AFCEE Galena Triad Meeting No. 8

ATTENDEES: See Attached
FROM: CH2M HILL
DATE: September 27, 2011

Site Name: ST020
Investigation Type: SC
Analytes: All Exceedences
Media: Soil
SLs: Soil Extent
Data Range: 2011

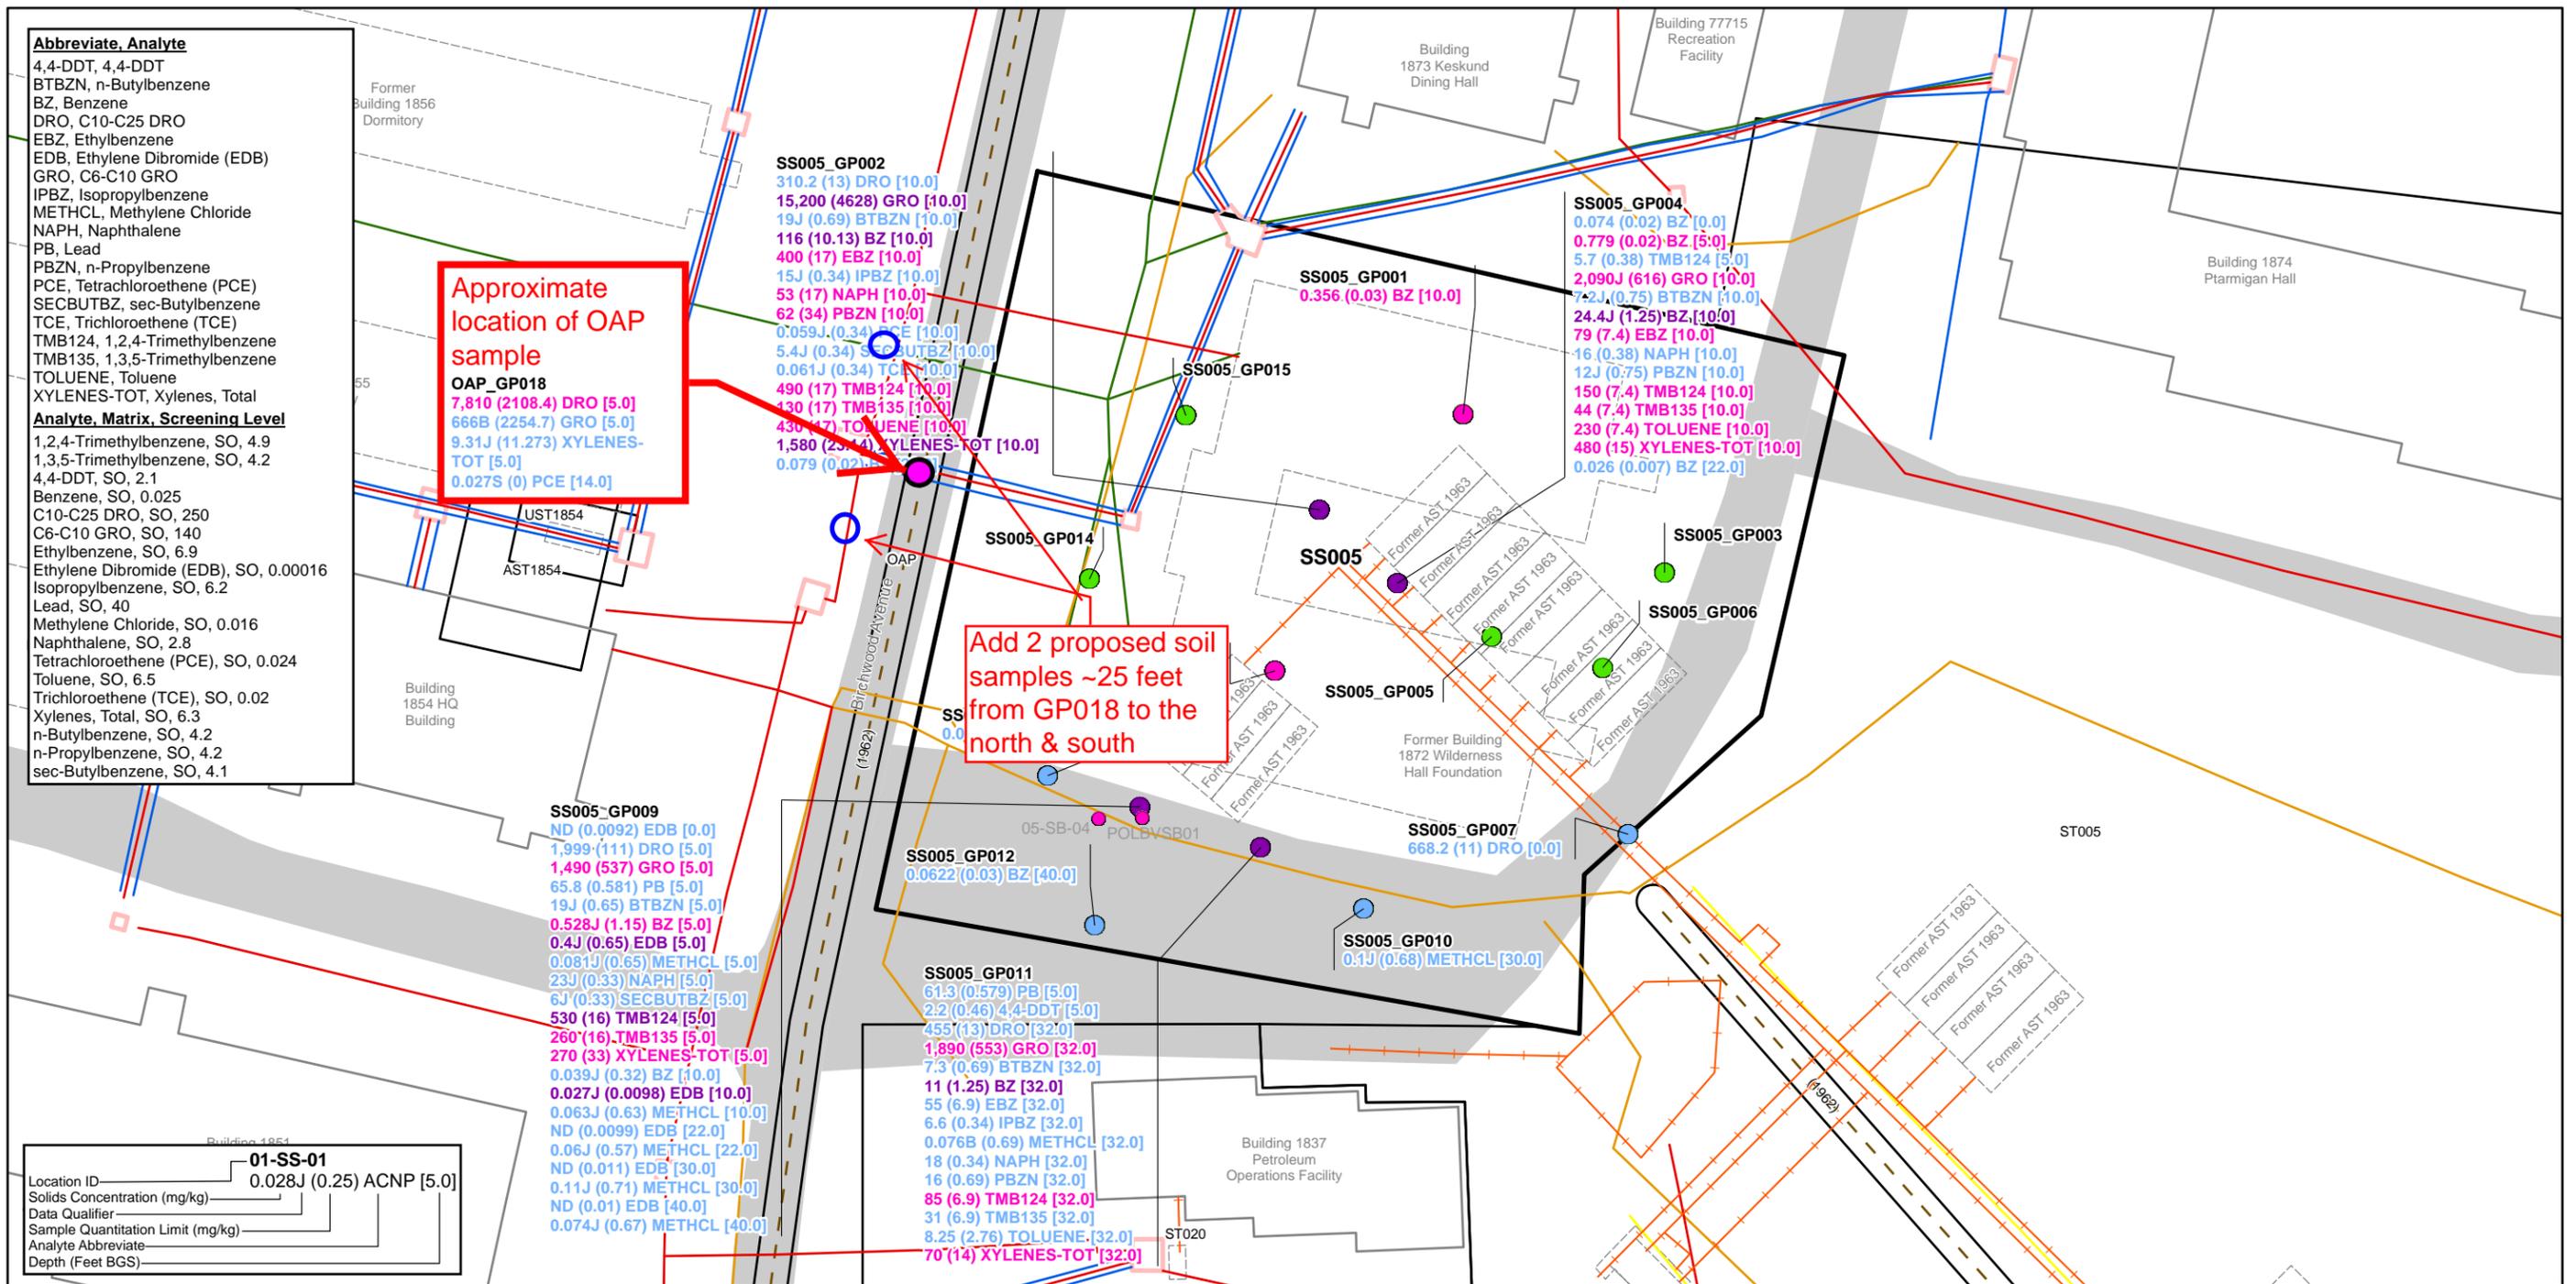
The soil results from the initial samples at ST020 indicate that the contamination has been delineated vertically for the site. One stepout was proposed for soil to laterally delineate DRO to the east of GP006. Groundwater results are not yet available. ADEC requested that the AF

double check historical drawings to determine the location of the pipeline that led from the building to the former UST. An additional stepout was discussed to the south of GP002 and GP006 to bound the contamination to the south.

- The team agreed to 2 stepouts for soil. The AF will double check figures for the former pipeline location and determine if additional stepouts are needed (*completed – the pipeline location has been confirmed and sample GP001 is located adjacent to the pipeline – additional stepouts are not proposed*).

SS016 -
 Stepouts

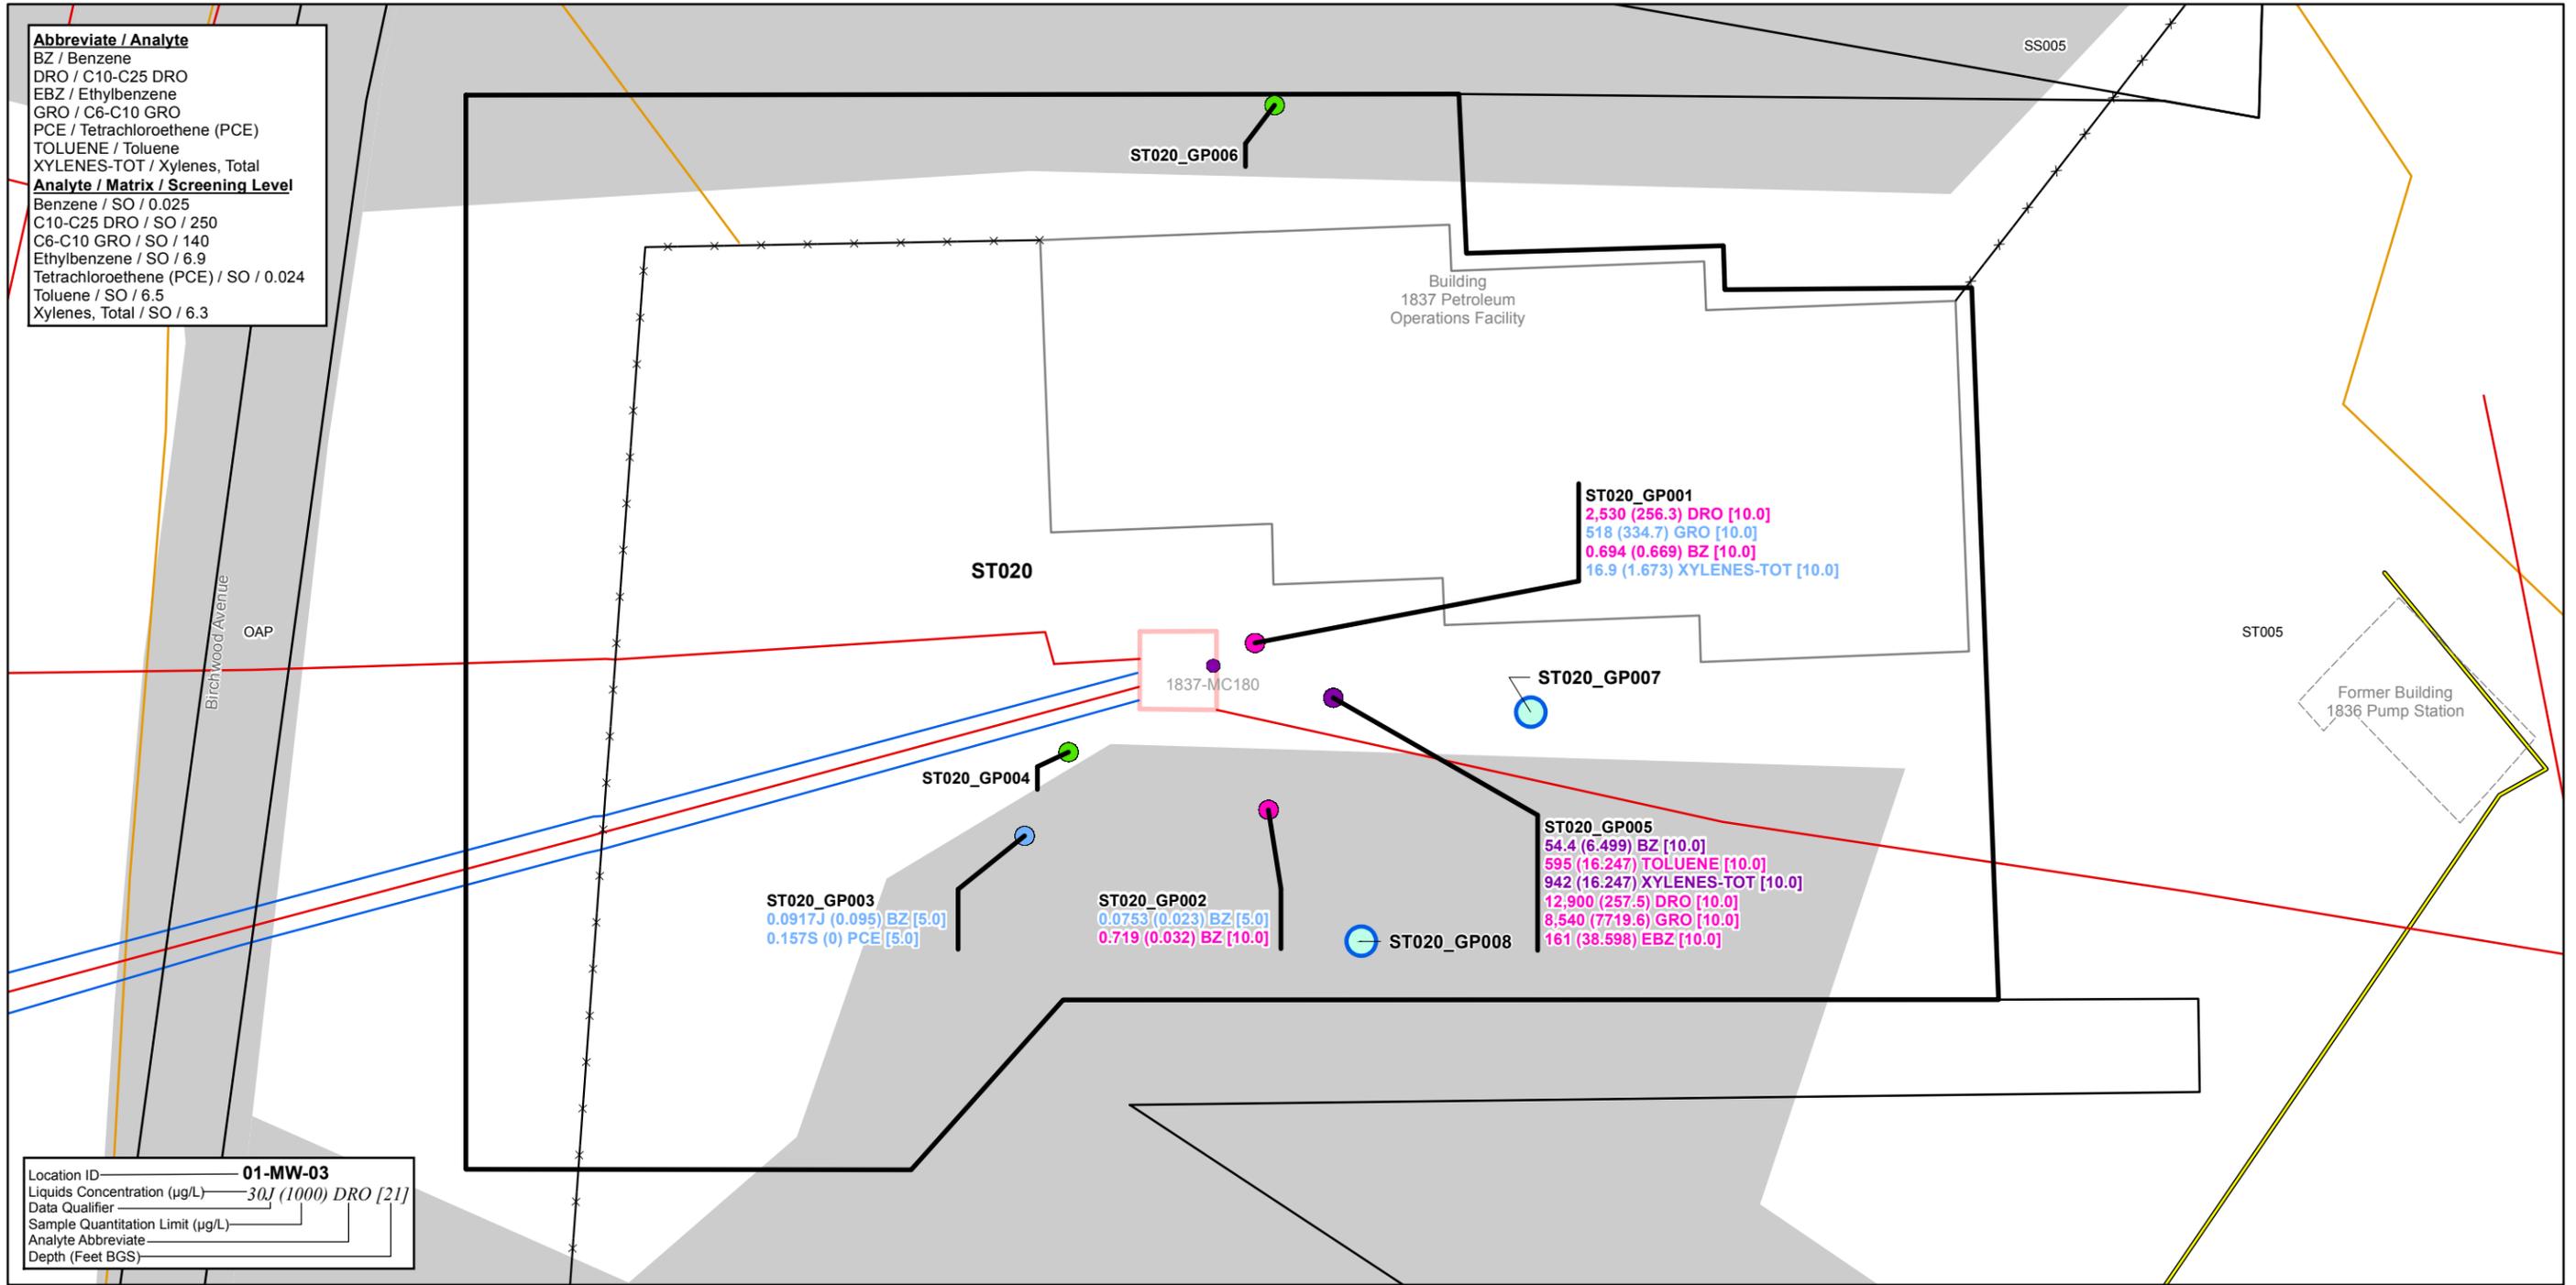
All soil data was presented. CH2M HILL proposed 1 stepout to the east of GP018 to delineate DRO. ADEC requested that the groundwater data for SS016 be presented on a future triad call.

- The team agreed to one soil stepout location.
